APPLICATION NO.	FILING DATE	FIRST NAMED INVENTOR	ATTORNEY DOCKET NO.	CONFIRMATION NO.
09/581,997	09/07/2000	Harri Lehtonen	023600-227	7978

Office Action Summary

This Office Action is in response to the amendment filed February 3, 2004 for the above identified patent application.

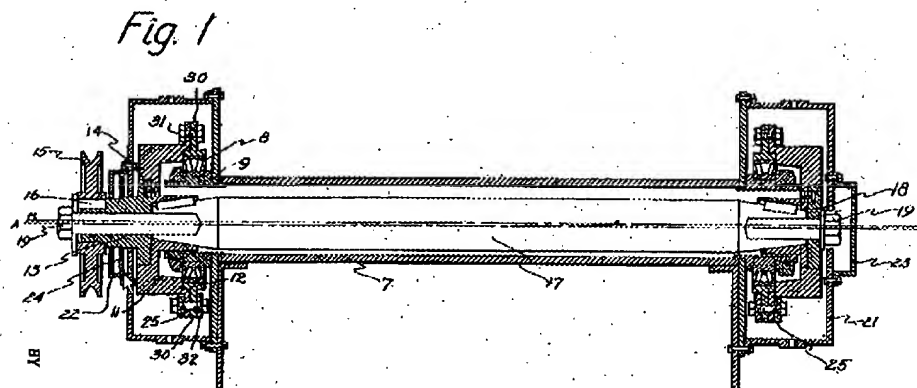
Figure 1 of Soldan illustrates a vibrating device comprising a rigid shaft (17) having shaft sections attached to reduced diameter portions thereof, each shaft section supported by essentially one bearing (8), an eccentric weight (25,32) connected to the shaft portion, the joint is rigid and adapted to transmit bending moment, wherein the shaft sections being connected to the rigid central portion results in the shaft being longer than the rigid central portion. See Figure 1 of Soldan below.

With respect to claim 13, the limitation "a length" is considered to be the length between the tapered portions of Soldan.
